INDESIT company

Model type:
BAAN12FR

Commercial code:
F044462

n1030093: New fixing of evaporator on static fridge-freezers (05 range) 60 cm,Melano

N1030093fig1

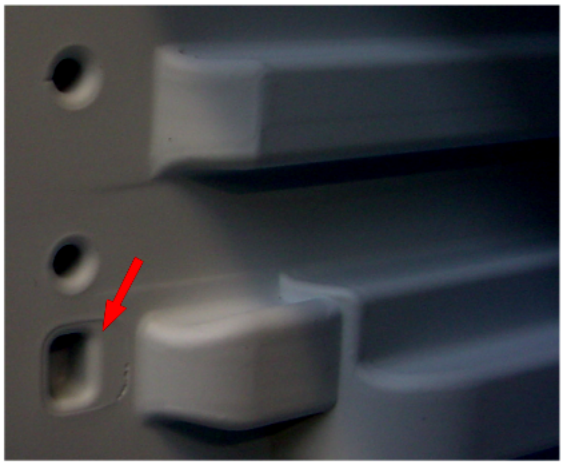
From August 05 (serial no. 50802.0001) the freezer evaporator is secured to the cabinet by a plastic profile.
The cabinet walls have been modified to create locations to house the profile, which is installed on the front of each evaporator plate (see photo N1030093fig1- fig2 - fig3)
The profile cannot be fitted on premodification appliances, so technical personnel must continue to fit the rh and lh supports on these models (see photo N1030093fig4)

New parts
C00141135 = WHITE PROFILE L=443.5 MM

Parts replaced
C00075596 = EVAPORATOR RH SUPPORT
C00075597 = EVAPORATOR LH SUPPORT
